RE: Comments Soda Mountain Solar Project Draft Plan Amendment/
Environmental Impact Statement/Environmental Impact Report, November
2013 CACA #049584 (SCH 2013101055)

Subject: Comments on the Draft Plan Amendment/Environmental Impact Statement/Environmental Impact Report prepared for the Soda Mountain Solar Project

EXAMPLE OF MONTHLY MAP

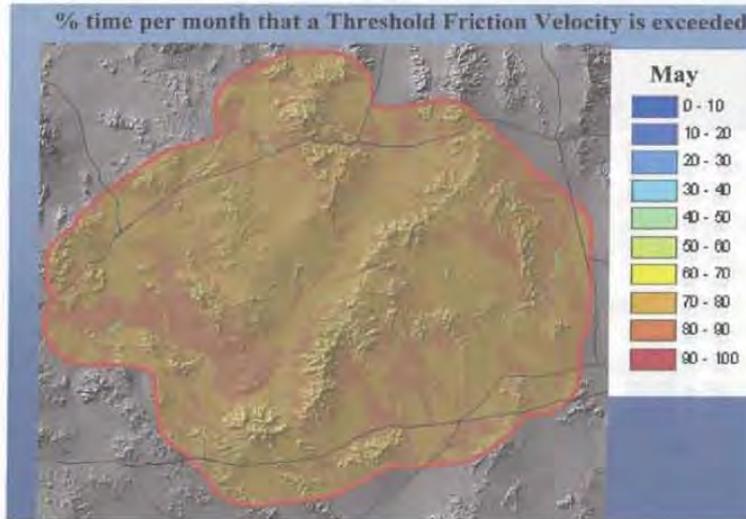
THE DOCUMENT DOES NOT ADEQUATELY ADDRESS FUGITIVE DUST AND WATER QUANTITIES NEEDED FOR SUPPRESSION.

The SMSP estimates it will use 192 AFY to control dust on approximately 2,700 acres or an amount of water equal to **0.07 AF/Acre**. This quantity is similar to amounts projected for construction of the three 100 acre solar fields in the Morongo Basin (MB). In actuality, when completed the MB projects had **used from 0.4 to 0.57 AF/Acre: approximately 10 times the projected amount**. Even so, on occasion downwind residents were subjected to high enough dust levels during construction to warrant staying indoors and the Marine Base issued travel alerts for its exit roads. The completed projects continue to emit dust when winds blow 20 mph and upward.

Figure 1

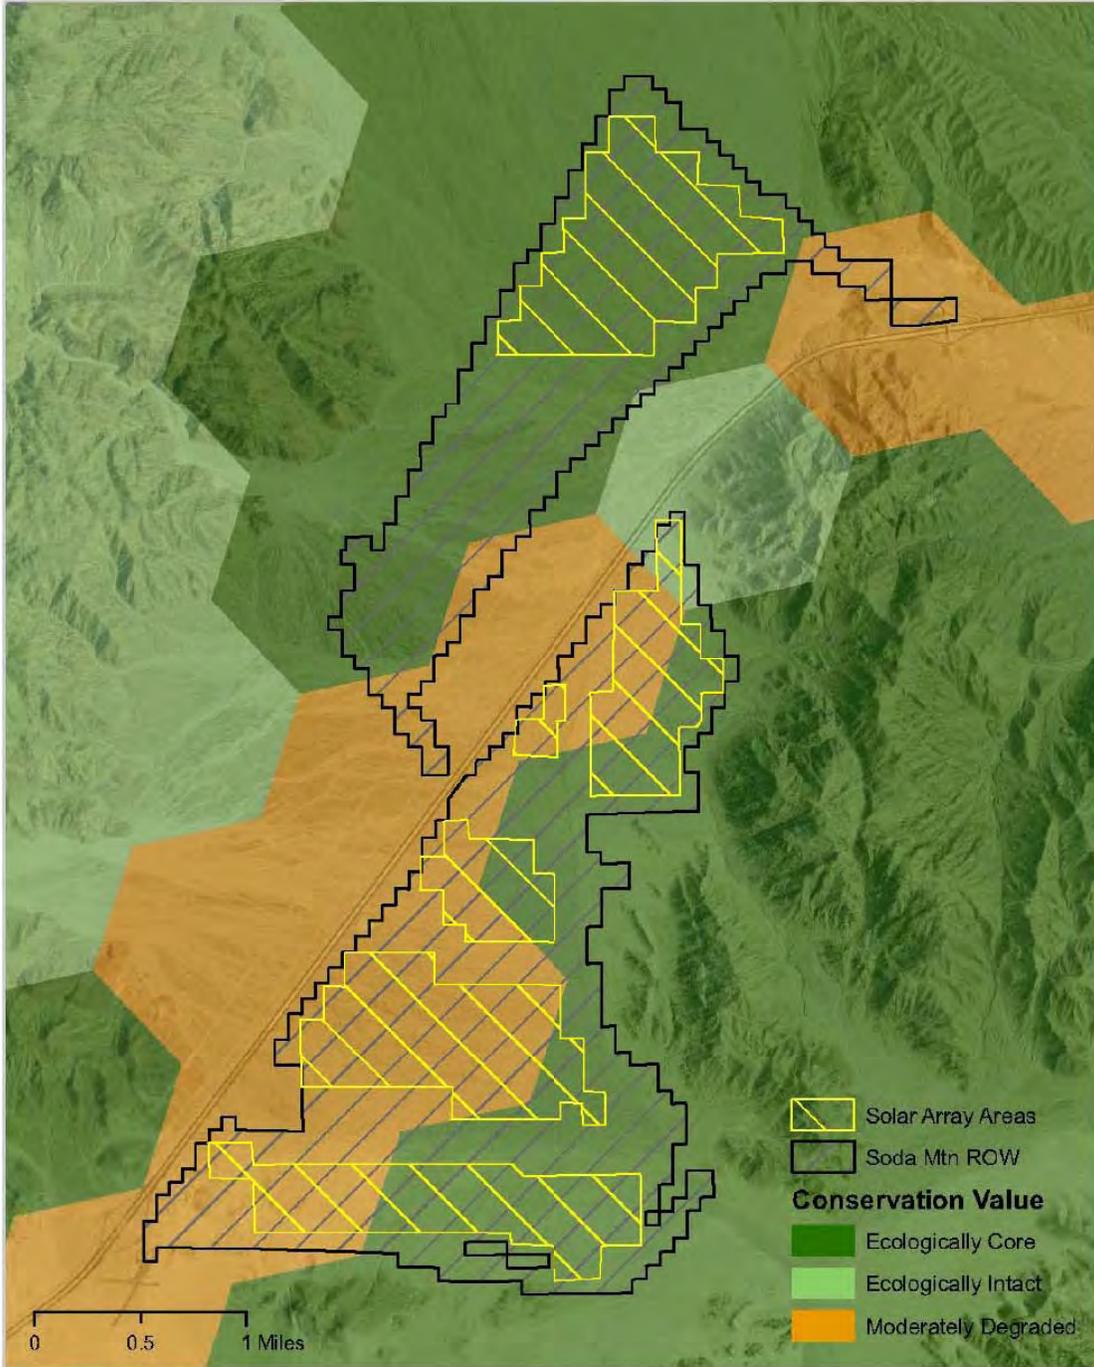
Soda Mountain ROW Conservation Value

Conservation Value from The Nature Conservancy, 2010
Solar Arrays Interpreted from Vol 2_Soda Mtn EIS-EIR_App A-D_508

Figure 3

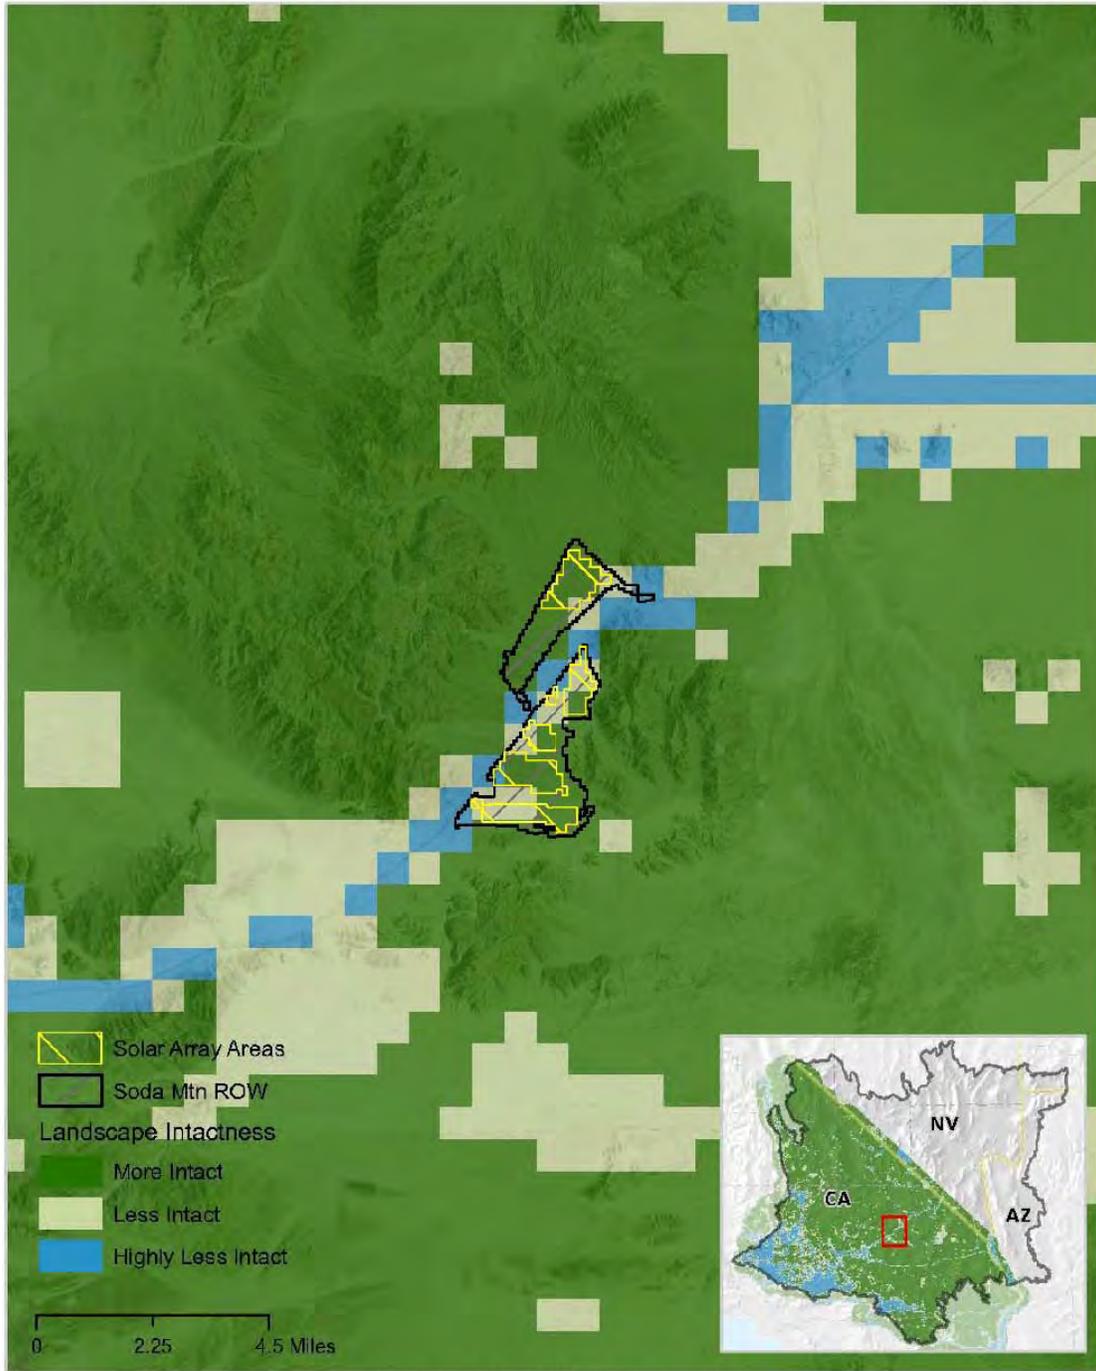
In addition to, and confirming the Conservancy’s analysis of the habitat values of this area, we have included a third map (Figure 3, titled “Intactness”) with the project area overlain on a map prepared and released by the DRECP agencies, that represents their assessment of habitat intactness in the desert.

Figure 4

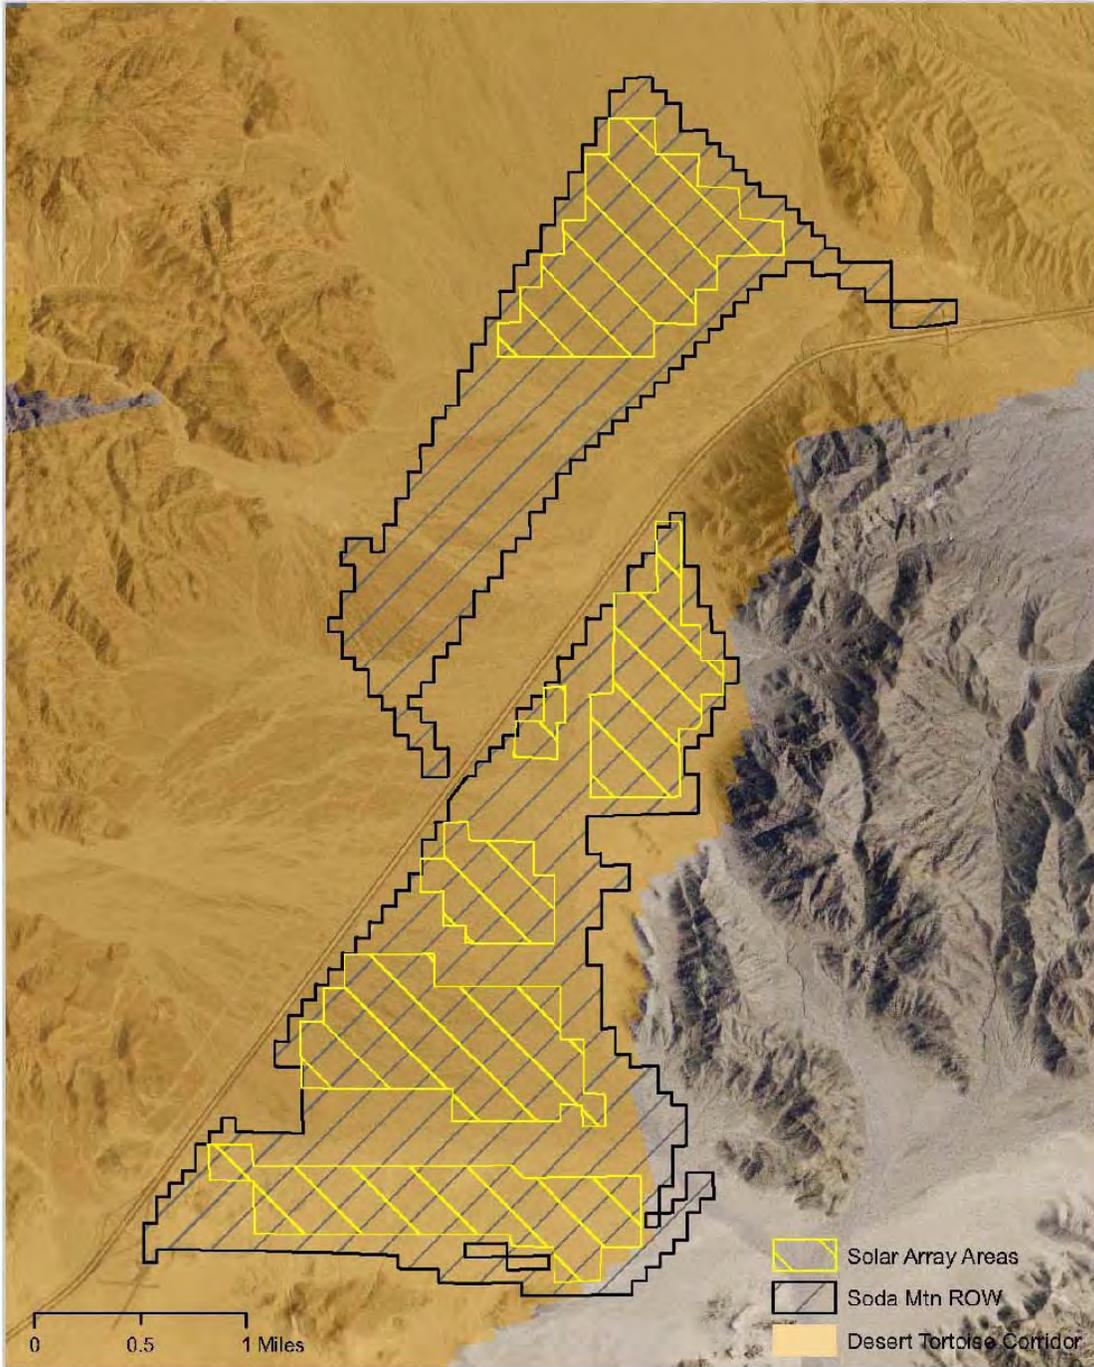
Desert tortoise (*Gopherus agassizii*) are present at the project site, and nearly the entire footprint for the project is located within a desert tortoise corridor as mapped by the USFWS (Averill-Murray et al. 2013; shown in light brown in Figure 4, titled “Desert Tortoise Corridors”). Preserving this connectivity for the desert tortoise is important for a number of reasons. The effective area of the 12 critical habitat units already designated for desert tortoise in the Mojave Desert will be increased by the linkage design, and the linkages will facilitate gene flow, prevent genetic isolation and divergence (Frankham 2006), and allow the desert tortoise to move in response to changes in climate or other conditions (Krosby et al. 2010). The Biological Resources Technical Report for the Soda Mountain Solar Project states that “limited sign of desert tortoise, combined with no identification of live tortoises in any of the project area surveys, indicate that there are likely a low number of desert tortoises inhabiting the project site” (Kiva Biological 2012a). “The data also indicate those tortoises are likely concentrated near the toes of hill slopes surrounding the project.” While desert tortoises may not have been recorded during official surveys, at least one live tortoise was observed on the project site (Jones 2013), and significant signs of desert tortoise were observed during each survey. Interference with a significant tortoise mitigation corridor should be avoided, and proposed mitigation in the form of 1:1 habitat acquisition is inadequate.
